City of Avondale Estates
Planning Architectural Zoning Board
Staff Review, Variances *

November 17, 2025, PAZB Meeting

Applicant: 278 Oak Holdings LLC: Jetha Wagner, Avila Development

Property Address: 136 Laredo Drive, 2968 Parry Street, 147 Oak Street, 2950 Franklin Street, and 2556 Franklin Street (Oak Parcel)

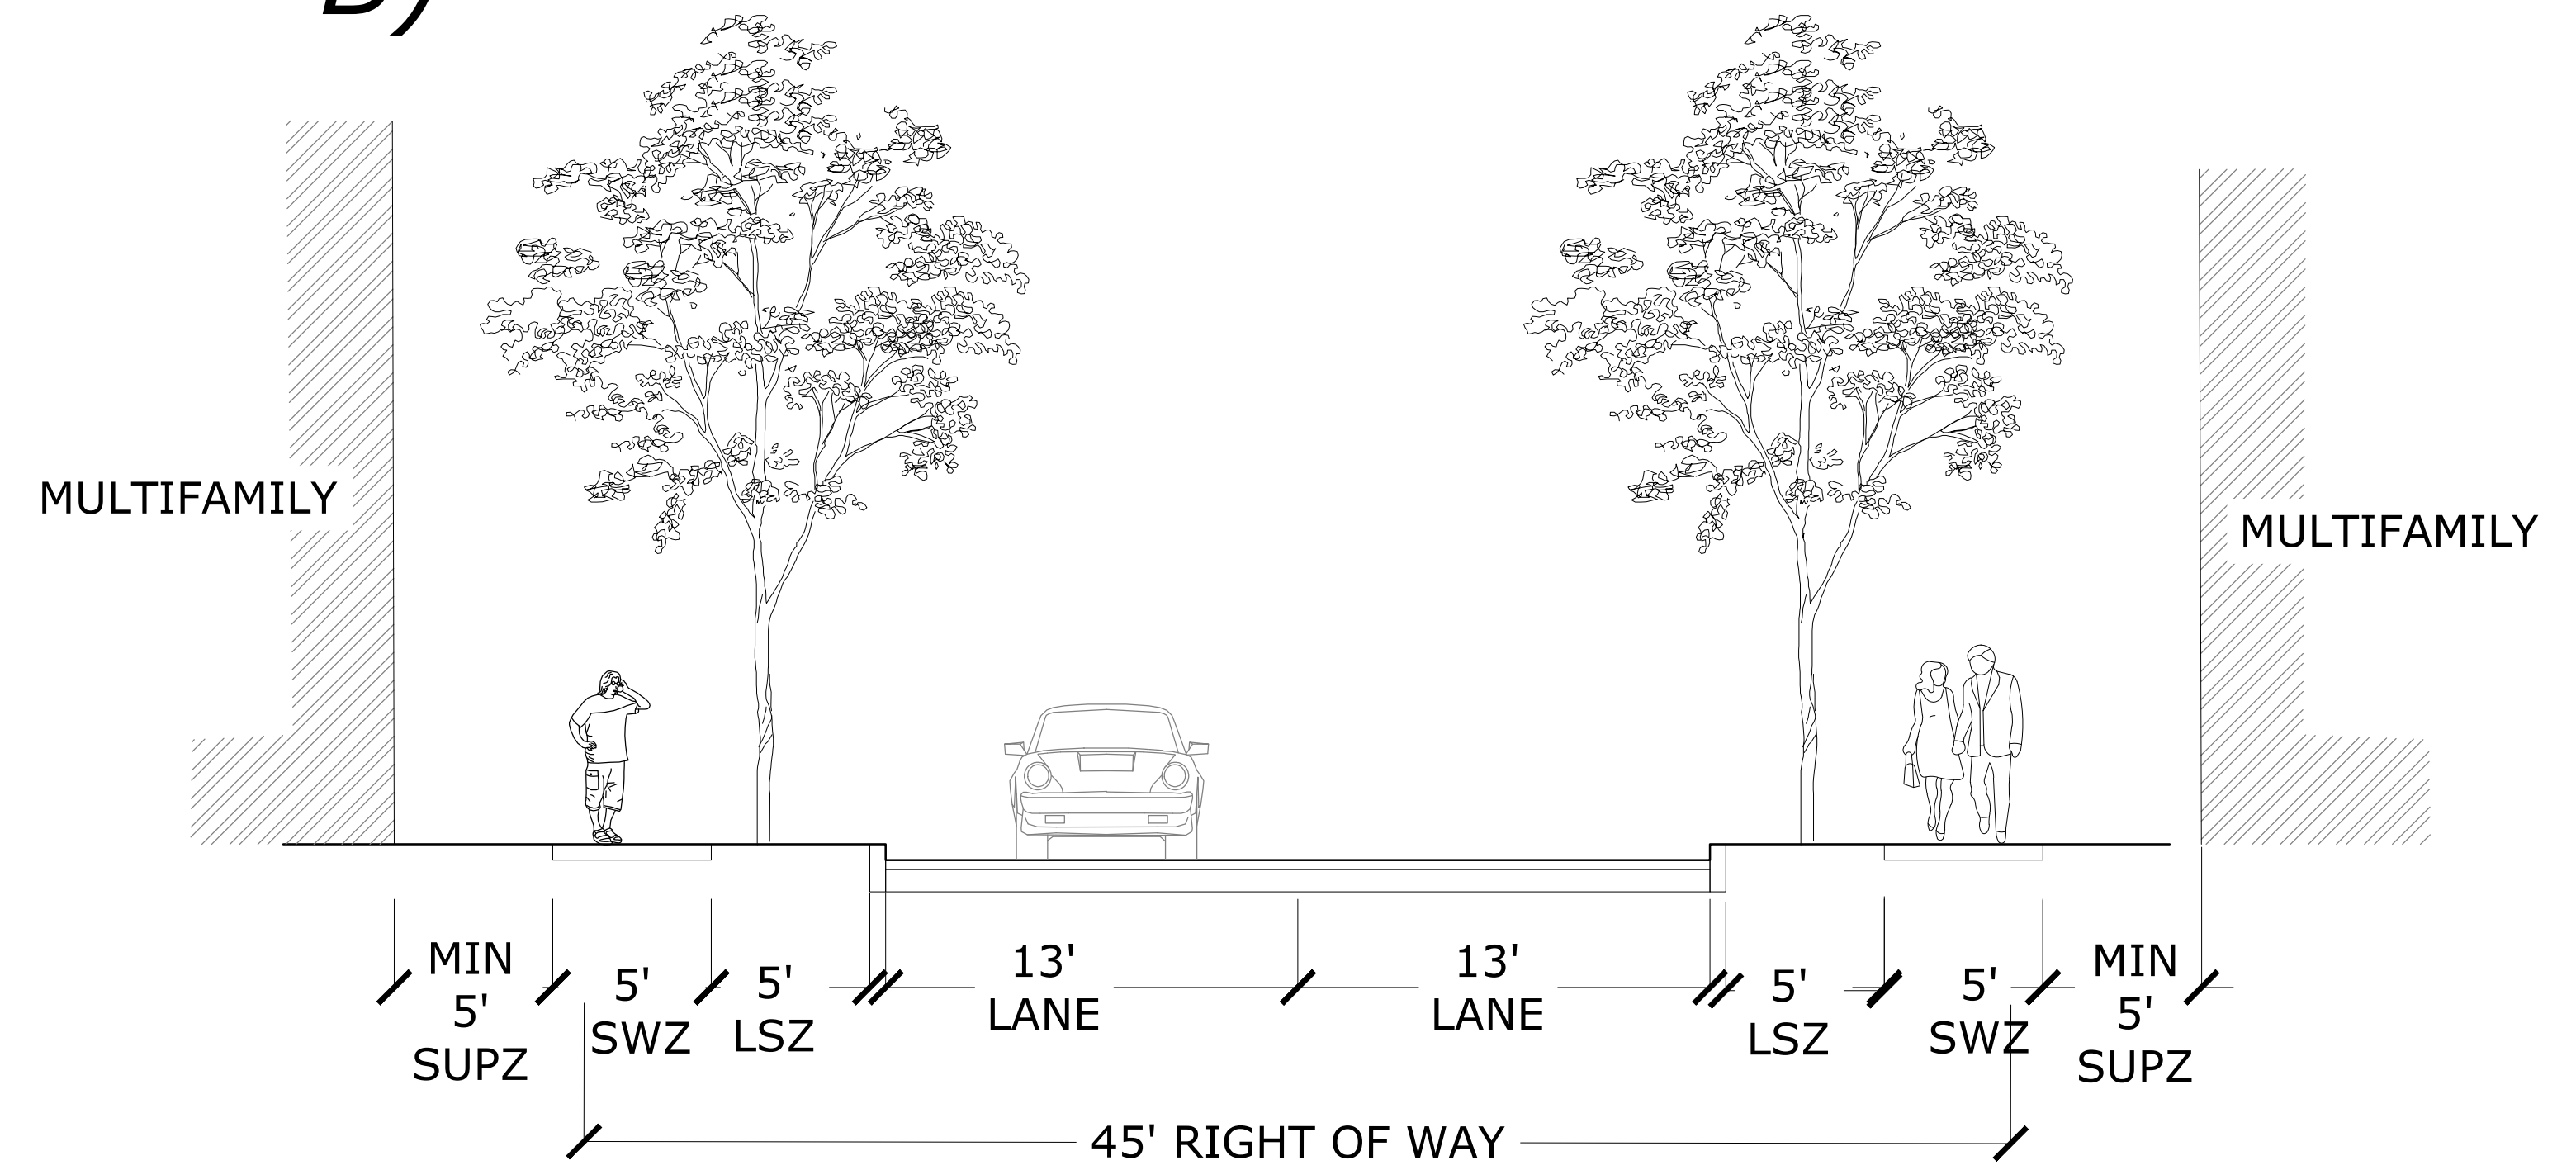
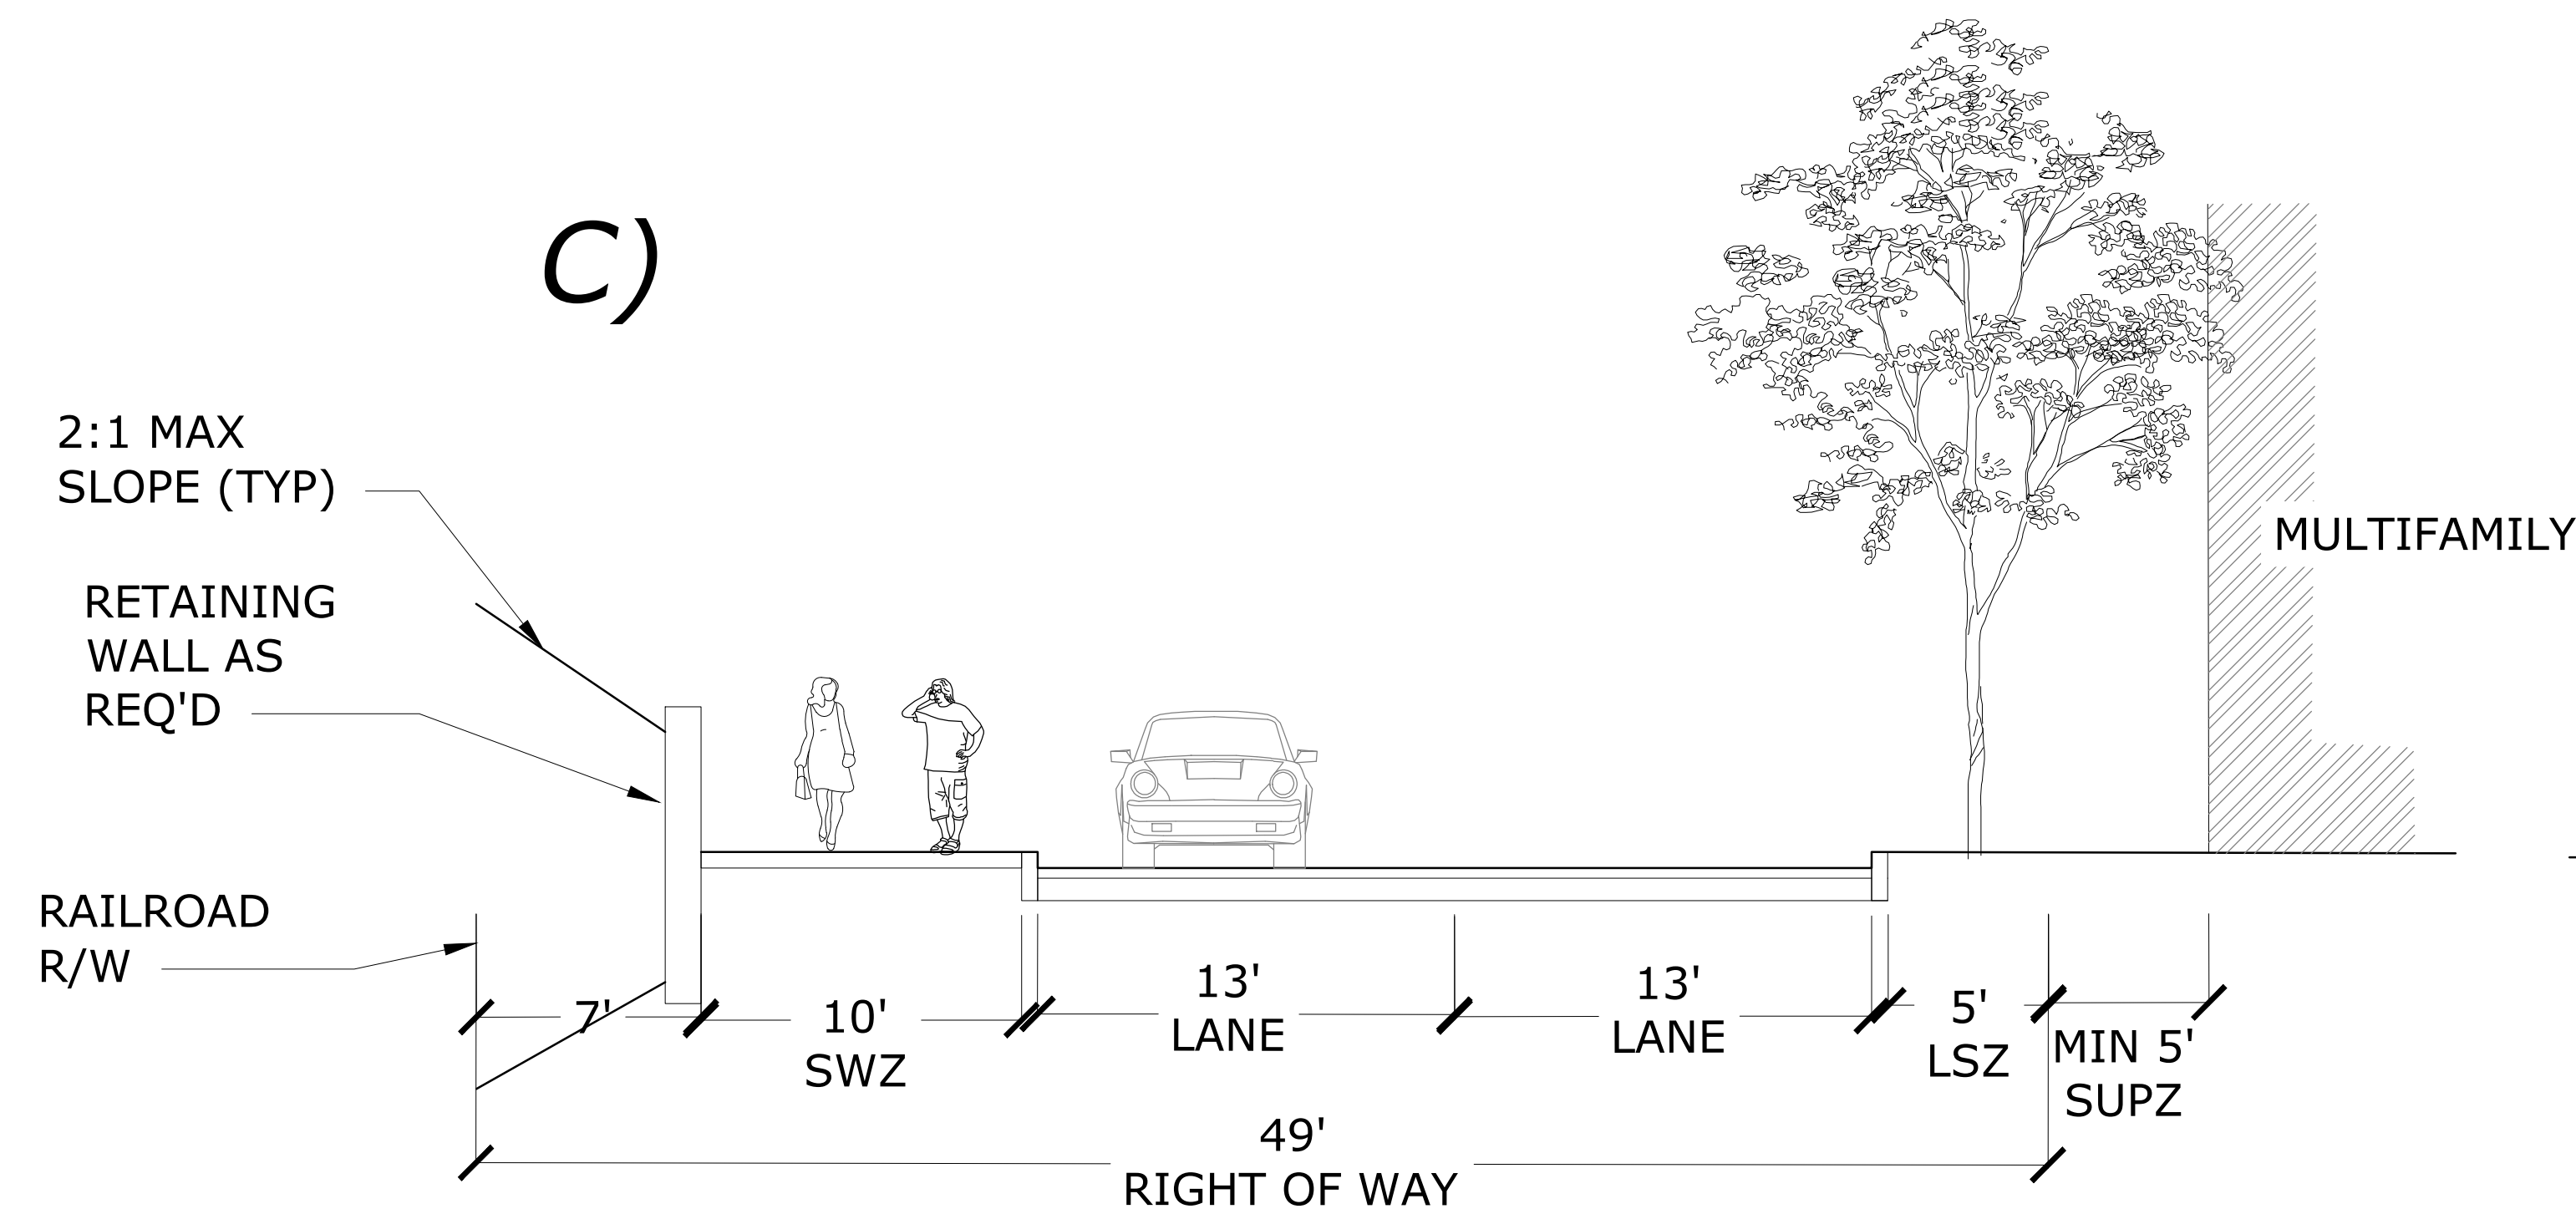
FROM: Figure 21-3.2.8.B.4.b and Table 3.2.8.E reduce type B2 street section from 60' ROW and 5' SUPZ to building face.

FROM: Figure 21-3.2.8.B.4.b and Table 3.2.8.E reduce type B3 street section from 45' ROW, 3 LSZ and 5' SUPZ to building face.

FROM: Figure 21-3.2.8.B.4.c and Table 3.2.8.E reduce type C1 street section from 55' ROW and 5' SUPZ to building face.

FROM: Figure 21-3.2.8.B.4.c and Table 3.2.8.E reduce type C2 street section from 40' ROW and 5' SUPZ to building face.

FROM: Figure 21-3.2.8.B.4.c and Table 3.2.8.E reduce type C1 street section from 55' ROW and 5' SUPZ to building face.

FROM: Figure 21-3.2.8.B.4.b and Table 3.2.8.E reduce type B1 street section from 72' ROW and 5' SUPZ to building face.

FROM: Figure 21-3.2.8.B.4.d and Table 3.2.8.E reduce type D street section from 40' ROW and 5' SUPZ to building face.
